Access Compliance Report

Public Rights-of-Way

(Curb Ramps)

Intersection ID: 14078	Main Street: EAST_BV	Cross Street: SOUTH_BV	Location: E
ADA ID: 91AA893BFE8F	Ramp Type: BlendTrans2	Initial Pass/Fail: Fail	Overall Compliance: No
Severity Score: 8.75			
Codes/Mitigation Info/Possible Solution		Field Measurements/Component Compliance

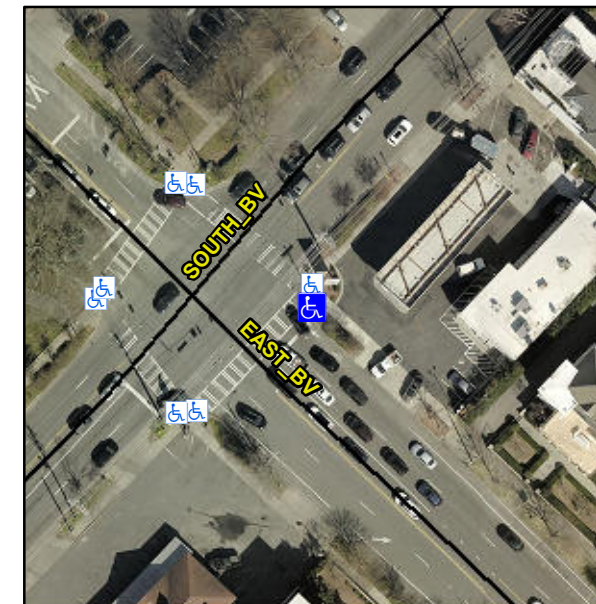
Not Found, R304.5.1

Compliance	Description	Data	Compliance	Description	Data
N/A	Ramp Length (in)	51.0	Yes	BlendTrans Slope (%)	0.1
No	Ramp Width (in)	45.0	Yes	BlendTrans XSlope (%)	0.6
N/A	Flare Type LT	N/A	N/A	Flare Type RT	N/A
N/A	Flare Slope LT (%)	N/A	N/A	Flare Slope RT (%)	N/A
N/A	Flare Traversable LT?	N/A	N/A	Flare Traversable RT?	N/A
N/A	Landing Length (in)	N/A	N/A	DWS Provided?	N/A
N/A	Landing Width (in)	N/A	N/A	DWS Contrast?	N/A
N/A	Landing Slope (%)	N/A	N/A	DWS Length (in)	N/A
N/A	Landing X Slope (%)	N/A	N/A	DWS Full Width?	N/A
N/A	Landing Curb? (Y/N)	N/A	N/A	DWS Offset (in)	N/A
N/A	Shared Landing?	N/A			
N/A	Gutter Ponding?	N/A	N/A	Gutter Slope (%)	N/A
N/A	Gutter Lip Ht (in)	N/A	N/A	Gutter X Slope (%)	N/A
N/A	Painted X Walk1?	Yes	N/A	Painted X Walk2?	N/A
	X Walk 1 Direction	To SW		X Walk 2 Direction	N/A
	X Walk 1 Width (in)	111.0		X Walk 2 Width (in)	N/A
	X Walk 1 Slope (%)	4.0		X Walk 2 Slope (%)	N/A
	X Walk 1 X Slope (%)	0.4		X Walk 2 X Slope (%)	N/A

N/A	Ramp inside XWalk1?	Yes	N/A	Ramp inside XWalk2?	N/A
	Road Slope (%)	0.4		Clear Space?	N/A
	Road X Slope (%)	4.0	N/A	Clear Space to XWalk (in)	N/A
N/A	Any Obstructions?	N/A	N/A	Storm Grate/Utility Hazard?	N/A
	Obstruction Type			Storm Grate/Utility Type	
		N/A			N/A
			Yes	Surface Condition? (G/P)	Good
			No	Curb Slope (%)	6.5

Remove & Replace Curb Ramp With Two New Directional Ramps or Equivalent.
